LINCOLN CITY/LANCASTER COUNTY PLANNING STAFF REPORT

for March 2, 2005 PLANNING COMMISSION MEETING

P.A.S.: Meadow View 2nd Addition Community Unit Plan
Change of Zone #05006, Co. Change of Zone # 05007, Special Permit 05003, Co. Special Permit #050004, Preliminary Plat #05001

PROPOSAL: A Change of Zone from AG to AGR, a Community Unit Plan with build-through and preliminary plat for 57 acreage residential units. All in split City and County jurisdiction.

BRILL ACRES DEVELOPERS
MEADOW VIEW 2ND ADDITION
PRELIMINARY PLAT AND C&P.
LANCASTER COUNTY, NC

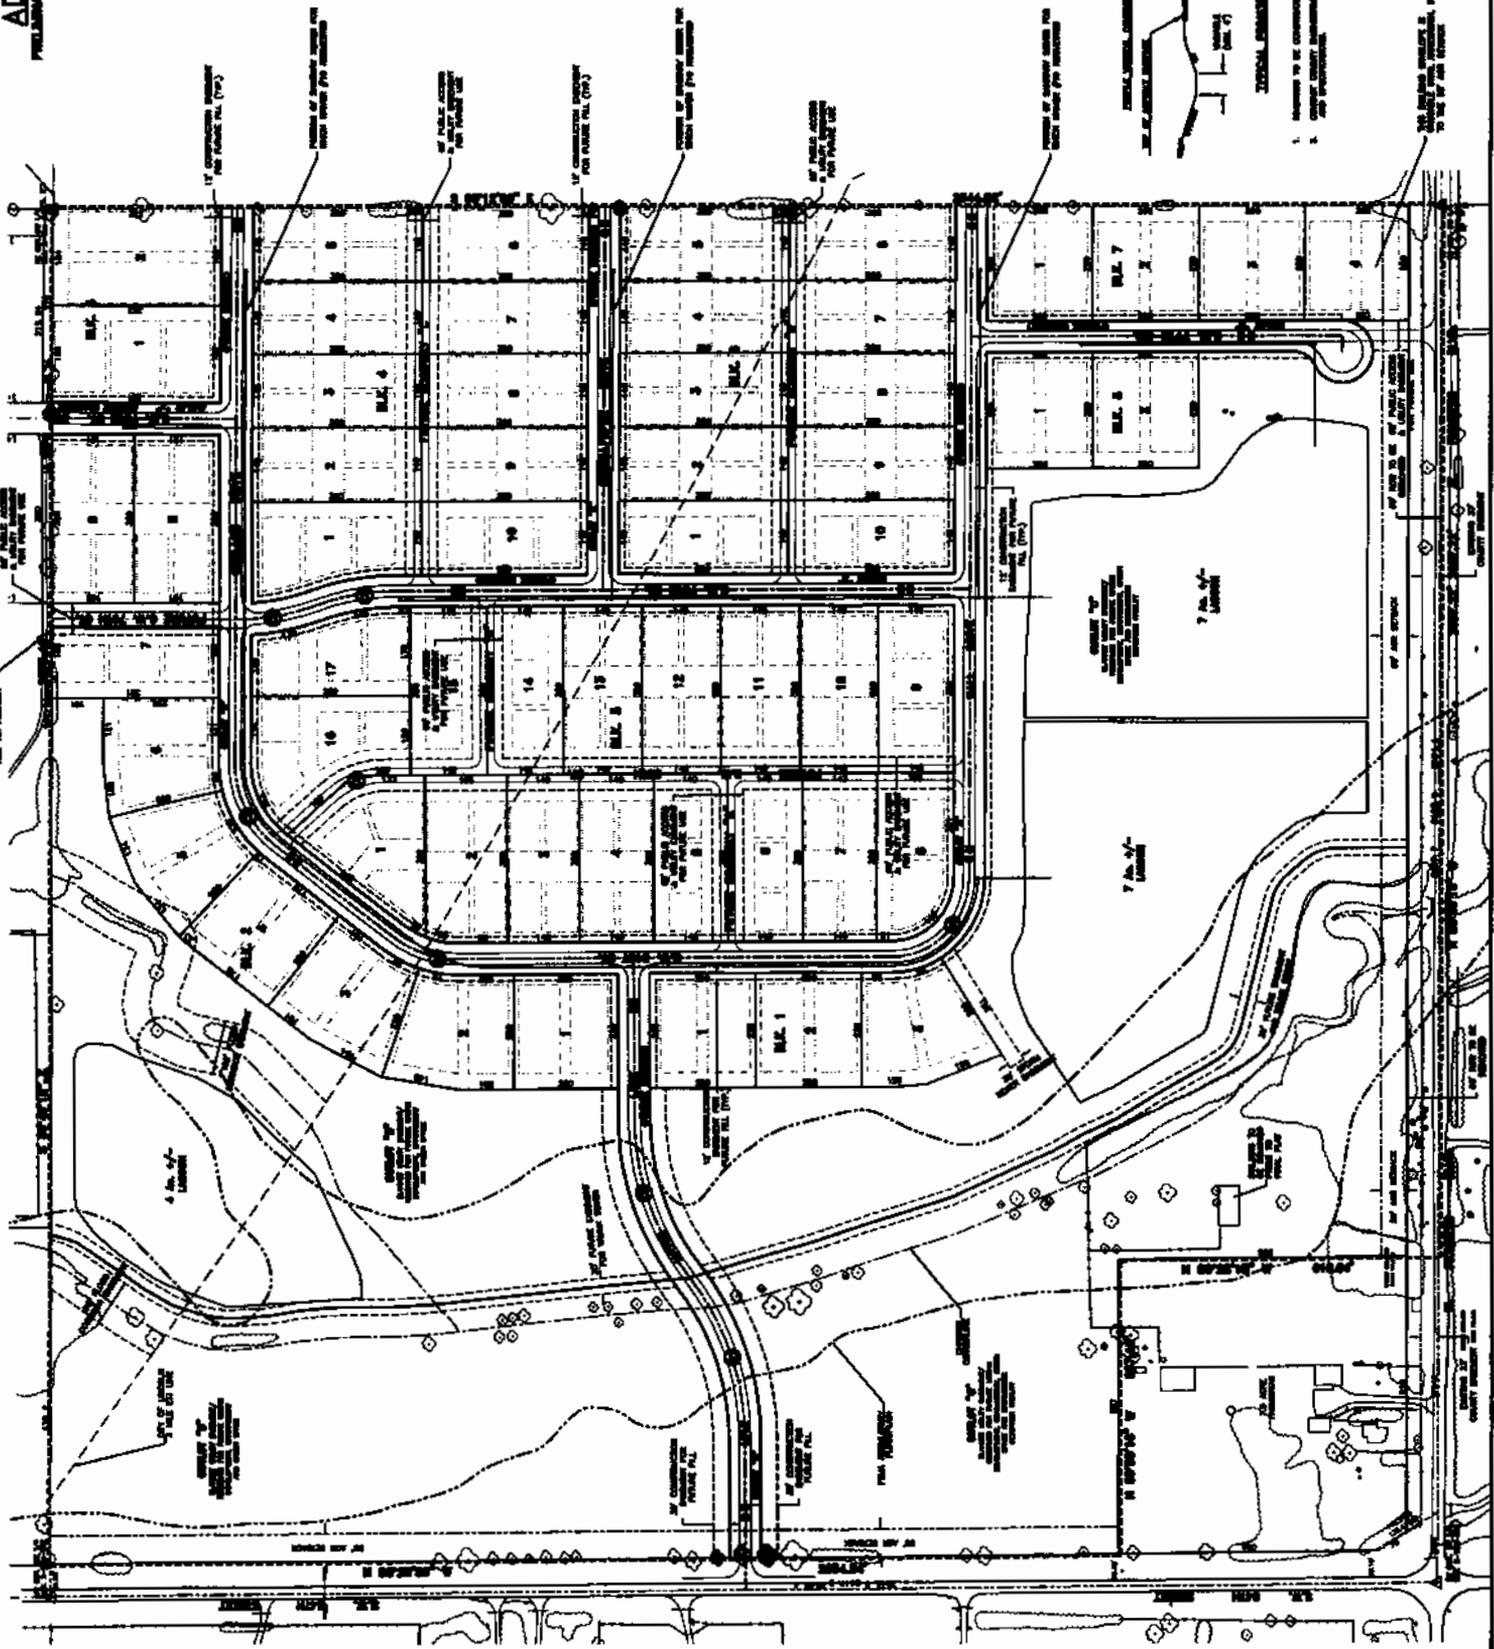
- 1.5 Revise the drawing to show the acreage of all lots and outlots.
 - 1.6 Revise the drawing to show all acreage lots less than one acre and the acreage development area component at no more than 40% of the total area.

- 1.7 Show provisions for the future connection of SW 77th with W. Pioneers Blvd. and rename the street as S. W. 77th Street.
 - 1.9 Show the easements requested by Norris Public Power.

- 1.10 Show the easements on all lots and future lots.
 - 1.11 Note a preservation easement on the flood plain.
 - 1.12 Show grading on all future streets.

- 1.13 Revise the street cross section to reference the Rural and Intermediate BTA.
 - 1.14 Show the minimum opening elevation for each dwelling.
 - 1.15 Add “with BTA” to the Title Block

- 1.18 Add a note that only one main building in a building envelope is allowed per platted lot.
 - 1.19 Note on page 3 this is the “Transitional Plat”.

- 1.20 Add a note stating that until Both S.W. 78th (at the north) access and Lyle Mayer Lane access to S.W. 84th Street are constructed, no more then 40 lots shall be final platted.

CULVERT #3

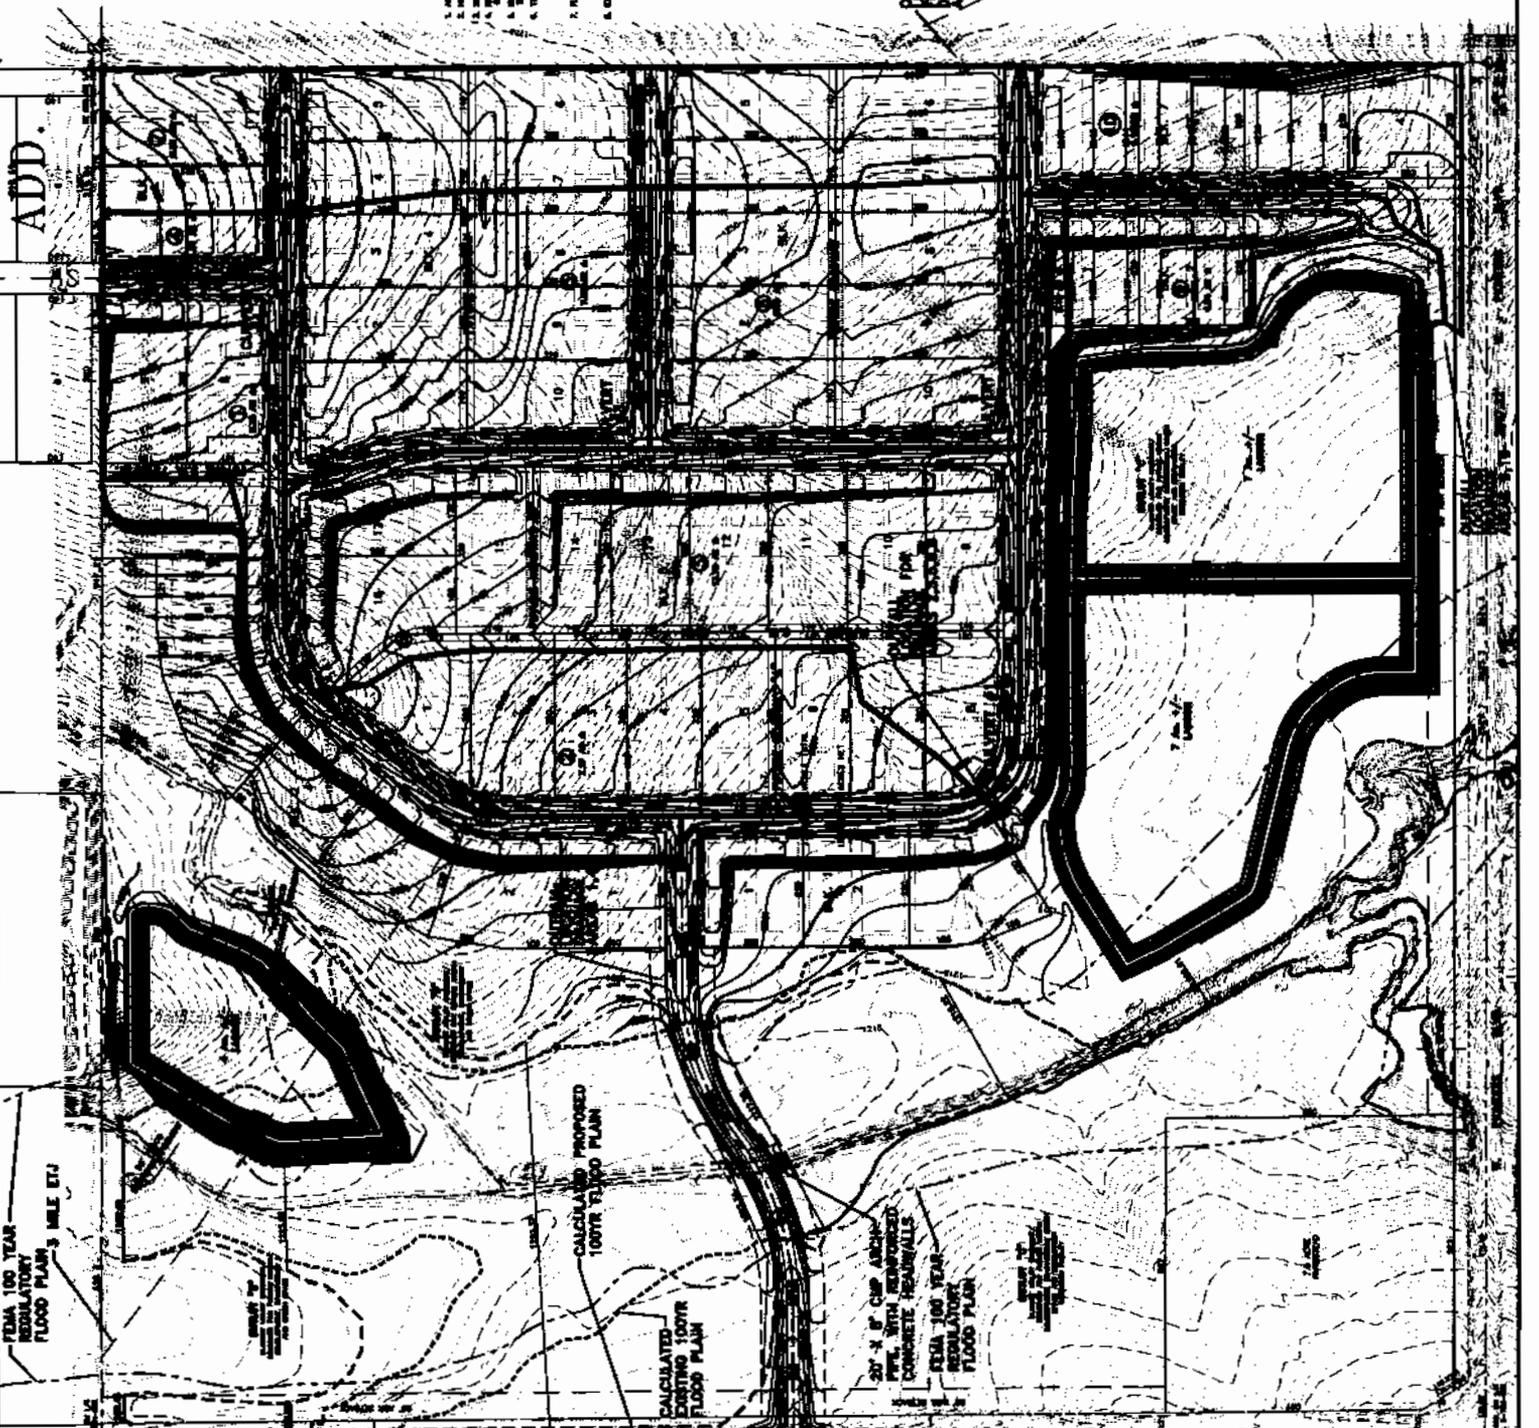
- 5) Culvert #4 shows a drainage area of 7.99 acres and a Q_{10} of 3 cfs. This does not appear to be correct.
- 6) Outlot "C" does not have any area left over for a future detention area due to the proposed lagoons.
